Docket Number:	15-AFC-02
Project Title:	Mission Rock Energy Center
TN #:	211990
Document Title:	Protocol Review
Description:	N/A
Filer:	Cenne Jackson
Organization:	San Joaquin Valley Air Pollution Control District
Submitter Role:	Public Agency
Submission Date:	6/27/2016 3:01:48 PM
Docketed Date:	6/27/2016

Subject: Mission Rock Energy Center

The following are the District's comments to the modeling protocol submitted on December 7, 2015.

Figure 1 - AAQA Process

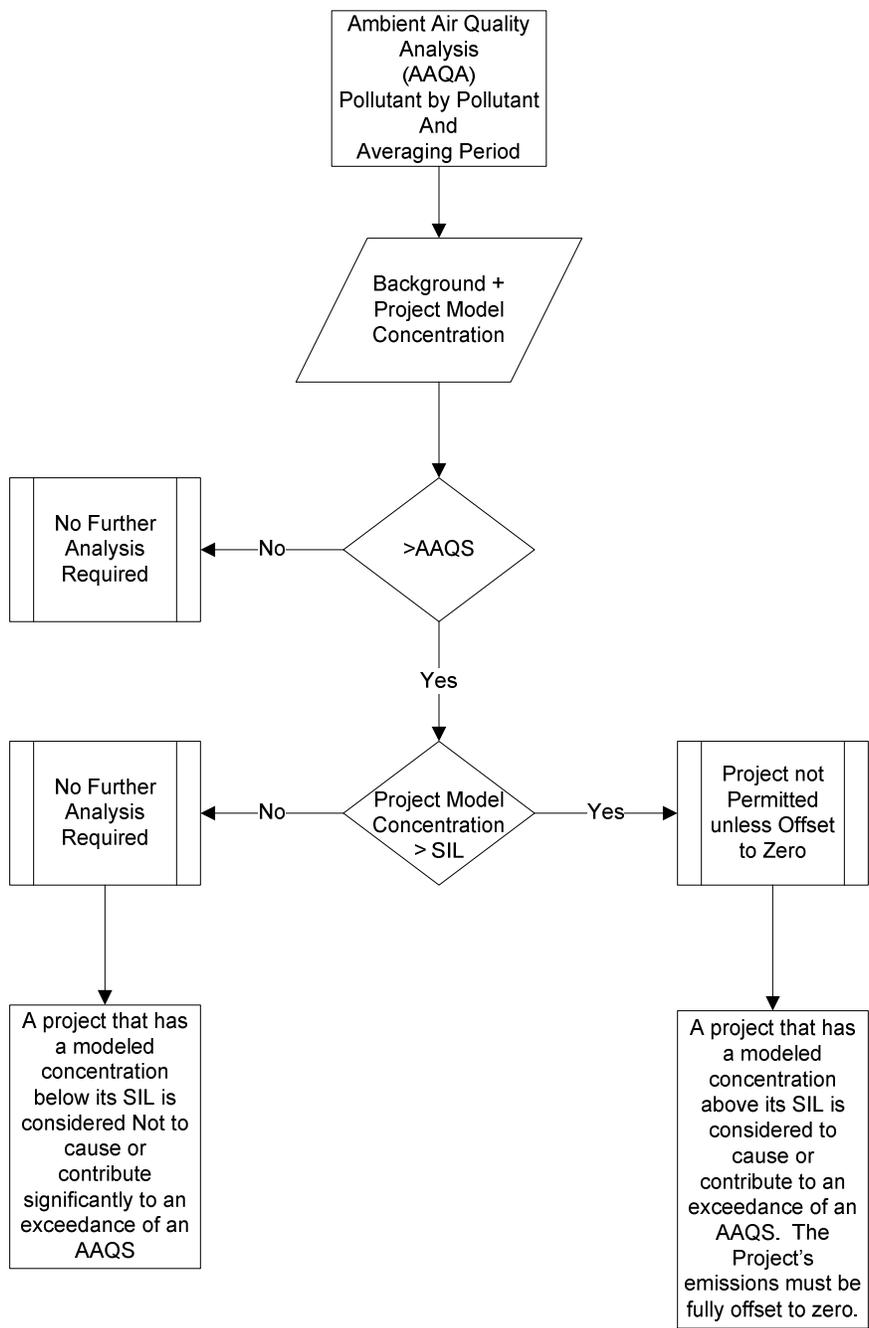
- 1) On pg. 18 of the modeling protocol, HARP version 2.03 and the HARP On-Ramp are listed as the programs that will be used to determine the health impacts from air toxics. The project proponent should use HARP2 version 16088 or later for determining all Cancer, Chronic and Acute impacts from the project.
- 2) The following additional information should be provided to the District for review:
 - a. All proposed toxic emission profiles used for the project.
 - b. All modeling inputs and outputs used for the project.
- 3) Upon review of the *Ambient Air Quality Analyses* section (see pg. 18 of the modeling protocol), it is unclear what the procedure will be for performing ambient air quality analyses (AAQA). The process by which the District evaluates AAQA's is as seen in Figure 1. The project proponent should ensure that they follow the same procedure when performing their AAQA.
